Rezoning Transportation Analysis

Petition Number: 2019-156

General Location Identifier: 08114708, 08114709

Date	Description
12-19-2019	First Review
02-18-2020	Second Review (WB)

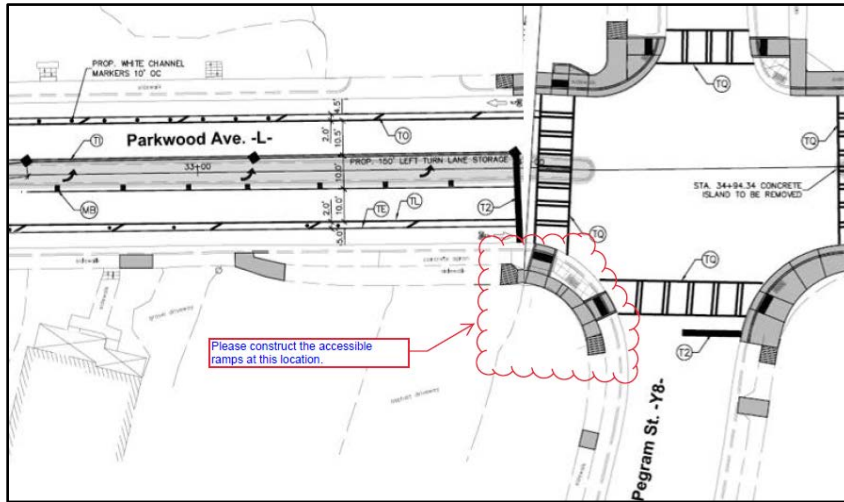
- ~~**Parkwood Avenue:**~~ The future location of curb and gutter is in its existing location.
- ~~**Pegram Street:**~~ The future location of curb and gutter is in its existing location.

~~The site plan should show the curb and gutter labeled and dimensioned from the centerline for each road.~~

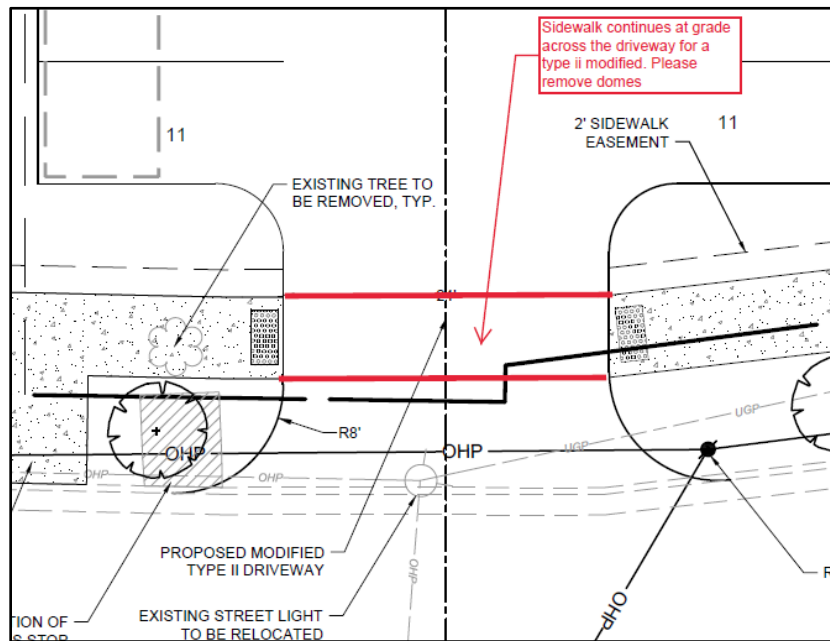
- ~~**Traffic Study**~~ A Traffic Impact Study is not necessary for the complete review of this petition.
- The petitioner should revise the site plan and conditional note(s) to commit to construct two directional ramps at the intersection of Parkwood Avenue and Pegram Street, per the *Parkwood (N. Davidson - The Plaza) Improvements* construction plans. Please refer to these plans within the rezoning site plan and conditional note(s). The Parkwood (N. Davidson – The Plaza) plans are available upon request.

4. The petitioner should revise the site plan and conditional note(s) to remove the truncated domes and to continue the sidewalk at-grade across the driveway.

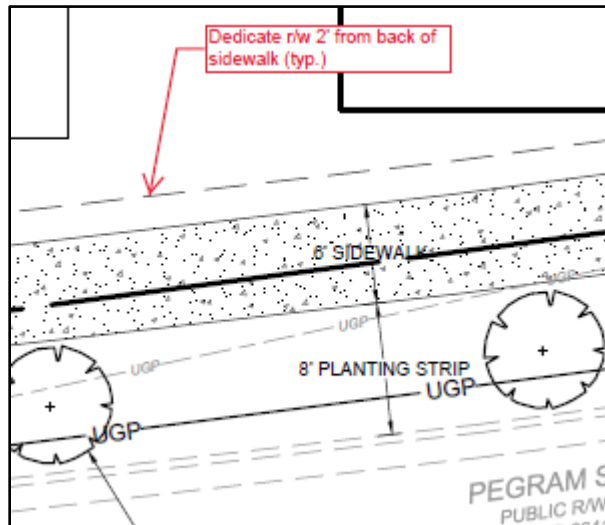
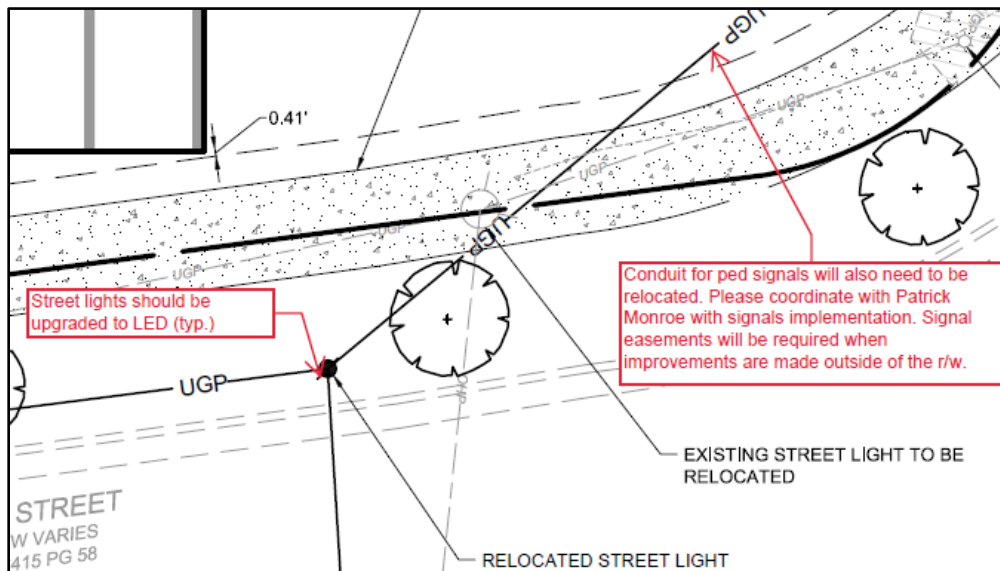
- The petitioner should revise the site plan and conditional note(s) to include utility easements where underground conduit is placed outside of the public r/w for the relocated street lights. The petitioner should commit to upgrading the street lighting along the site's right-of-way frontage to LED. Coordinate with Patrick Monroe (Patrick.Monroe@ci.charlotte.nc.us at 704-336-3937).
